City of El Paso – City Plan Commission Staff Report

Case No: SULD15-00001 Gateway Estates Land Study
Application Type: Land Study
CPC Hearing Date: February 11, 2016
Staff Planner: Alfredo Austin, (915) 212-1604, austinaj@elpasotexas.gov
Location: East of Joe Battle and North of Vista Del Sol
Acreage: 275.80 acres
Rep District: ETJ
Existing Use: Vacant
Existing Zoning: ETJ
Proposed Zoning: ETJ
Nearest Park: Three parks proposed inside subdivision (10.73 acres)
Nearest School: Capt. Walter E. Clarke Middle (1.11 miles)
Park Fees Required: N/A
Impact Fee Area: This land study is within the Eastside Impact Fee Area
Property Owner: GFA, LLC
Applicant: GFA, LLC
Representative: CEA Group

ATTACHMENT 3

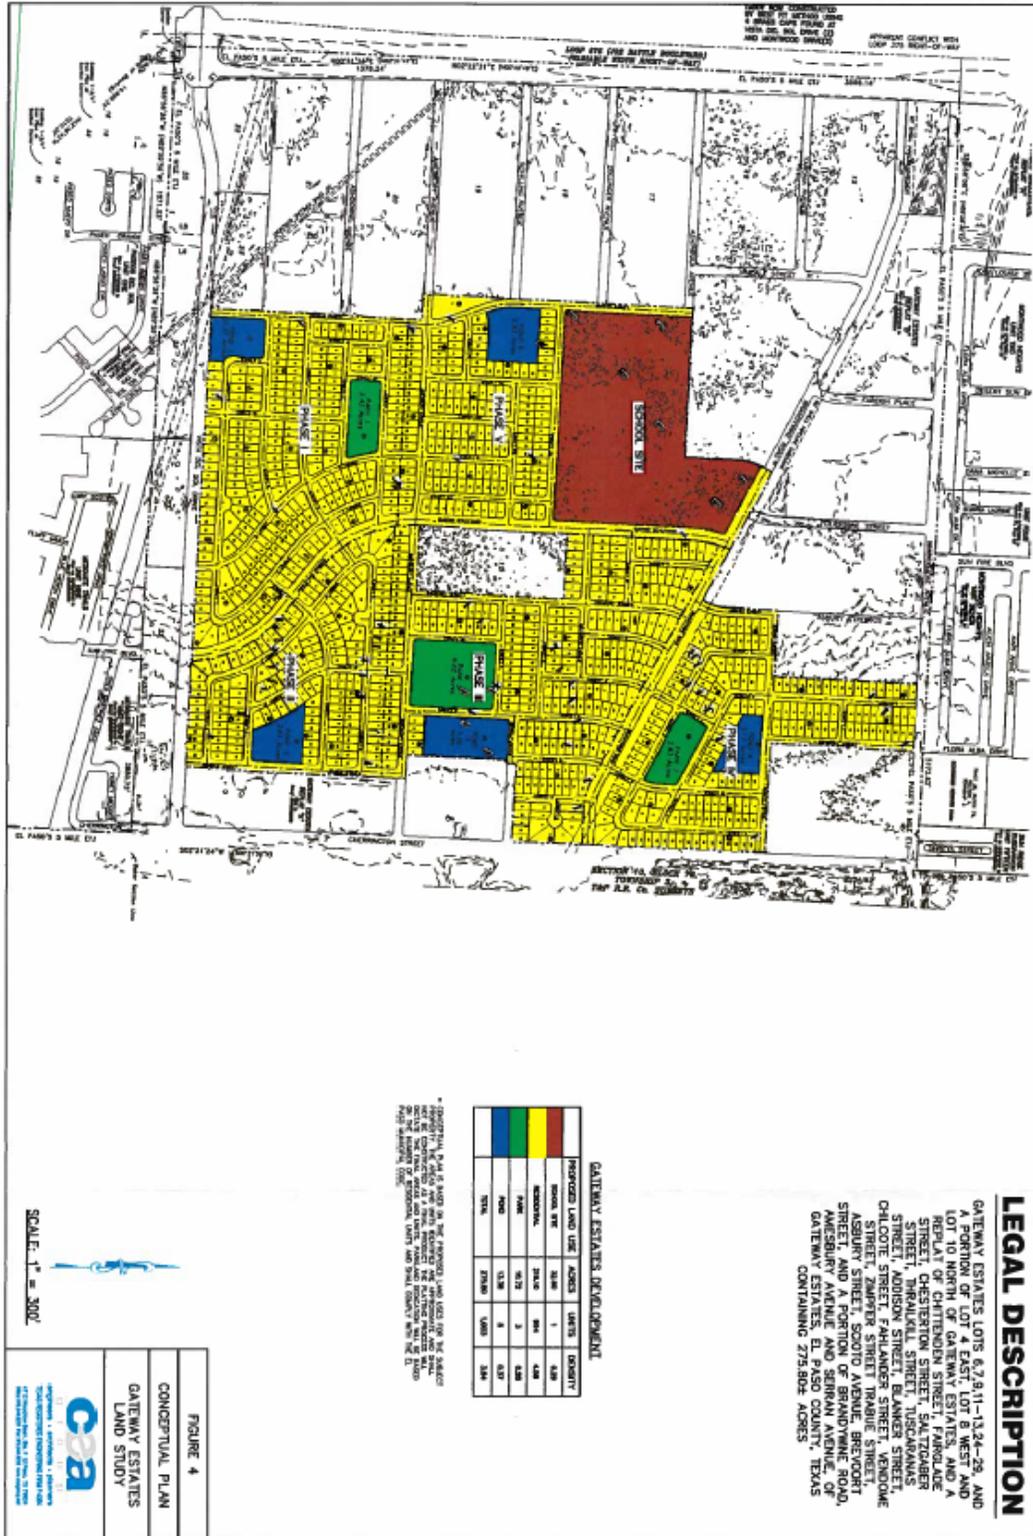
1. Clarify watersheds labeled WS-6 with notes stating if they are to retain their own water or specify runoff destination.
2. Show drainage flow pattern for the school site.
